**IN THE MATTER of Drury Metropolitan Centre Consolidated Stages
1 and 2 (the Project)**

JOINT WITNESS STATEMENT (JWS) IN RELATION TO:

Topic: Stormwater and Flooding (1)

Date 2 October 2025

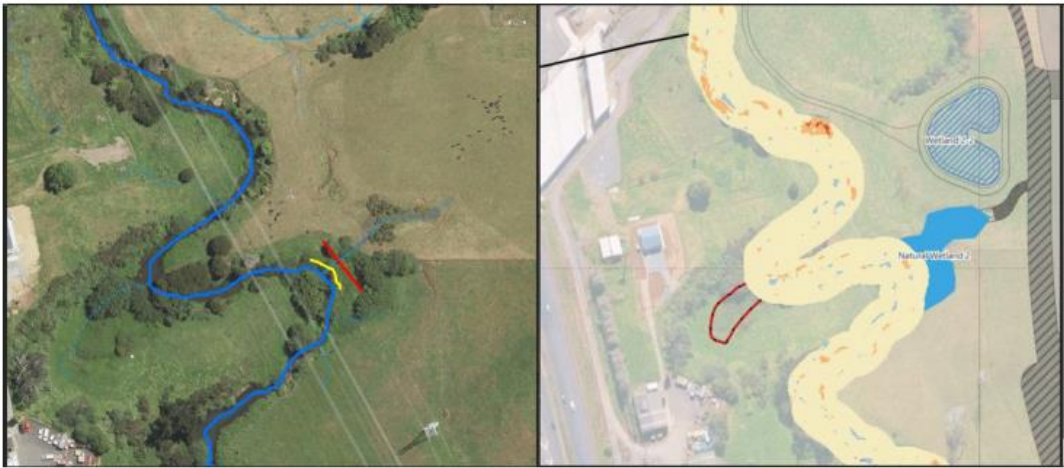
1.3	The Applicant must provide an <i>updated Overland Flow Path Assessment</i> to demonstrate that the overland flows can be managed to not create a flood hazard and risk to future public road users. It is not considered appropriate to defer resolution of remaining concerns in this regard to Engineering Plan Approval stage as any design changes	The Overland flow path assessment dated 14/07/2025 was submitted as part of the section 67 responses to Auckland Council. The assessment incorporated the primary stormwater network as per the proposed design. The blockage assumption applies to the primary network are consistent with the requirements set	The Applicant must provide an updated Overland Flow Path Assessment to demonstrate that the overland flows can be managed to not create a flood hazard and risk to future public road users The results of the Applicant’s overland flow assessments indicate no unacceptable hazard to public road users. Does HW accept this matter has been satisfactorily	The results of the overland flow assessments indicate no unacceptable hazard to public road users, apart from location at cross-sections XS2 and XS3 as described previously above.	We agree with N. Mark-Brown’s statement. A response regarding XS 2 and XS 3 has been provided in Item A above.

proposed road reserve. XS8 and XS9: The product of flow depth and average velocity does not exceed the threshold for people and vehicular safety (as there is no parking proposed at this location). Consistent with the previous assessment undertaken, the overland flow is not fully contained within the proposed road reserve (on the side of the reserve)), as this location is a low point where runoff discharges to the Stream and consistent with the design of the proposed road. As per the proposed design no overland flows originating from Stage 1 discharge towards Stage 2.			
--	--	---	--	--	--
